FOUR SEASON AIR CONDITIONING INFORMATION - CHEVROLET AND CAMARO Chevrolet Dealer Service Technical Bulletin

67-T-15	
Number:	
Ia	
Section:	
March 6	, 1967
Date:

FOUR SEASON AIR CONDITIONING PROBLEMS AND CORRECTION

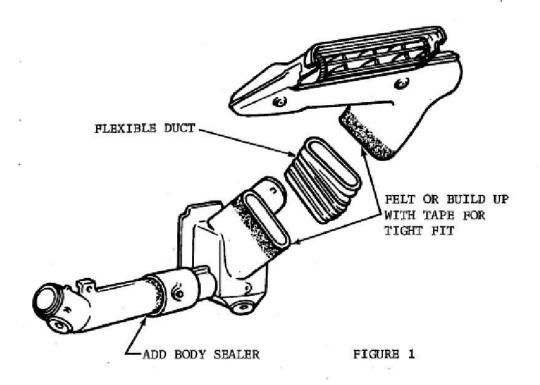
Some owners have expressed dissatisfaction with a lower volume of air coming from the side air outlets than in past years. The 1967 air distribution ducts have been designed to provide for improved rear seat cooling by having more air flowing out the center console duct. If the air volume at the side outlets is exceptionally weak, the duct system should be checked for possible air leaks at all connections. As necessary, duct joints should be taped and sealed (Refer to Figure 1).

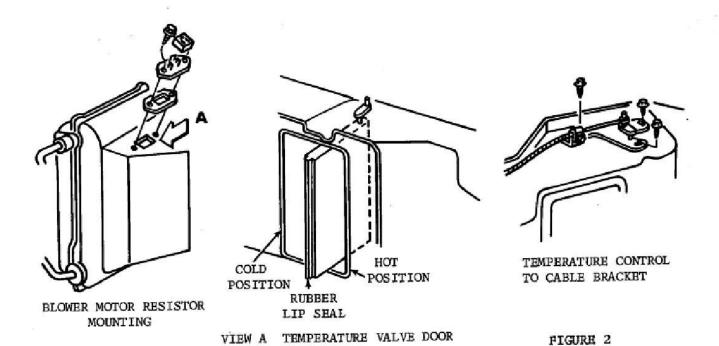
Remove the blower motor resistor from the evaporator housing and inspect, with the aid of a light through the resistor hole, the alignment of the door to housing in both the cold and hot positions (Refer to Figure 2). A properly adjusted door will have the rubber lip contact the seal against the white die cast housing for the full length of the door.

FIGURE 3

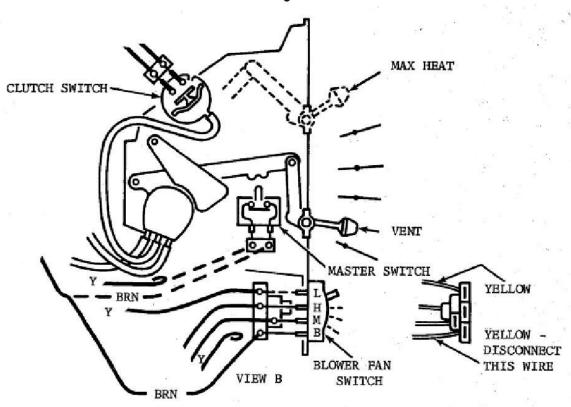
If complaints of the blower motor running during outside air venting are encountered, the master switch should be removed from the circuit by following the procedure as outlined in Figure 3. This revised wiring will make the blower motor manually operated at all times.

- 1. REMOVE YELLOW WIRE FROM "B" TERMINAL OF BLOWER FAN SWITCH AND CUT THE WIRE TERMINAL OFF AND TAPE BACK.
- 2. REROUTE BROWN WIRE FROM MASTER SWITCH AND CONNECT TO "B" TERMINAL OF BLOWER FAN SWITCH.
- 3. REMOVE YELLOW WIRE FROM MASTER SWITCH AND CUT OFF TERMINAL, TAPE BACK WIRE END.
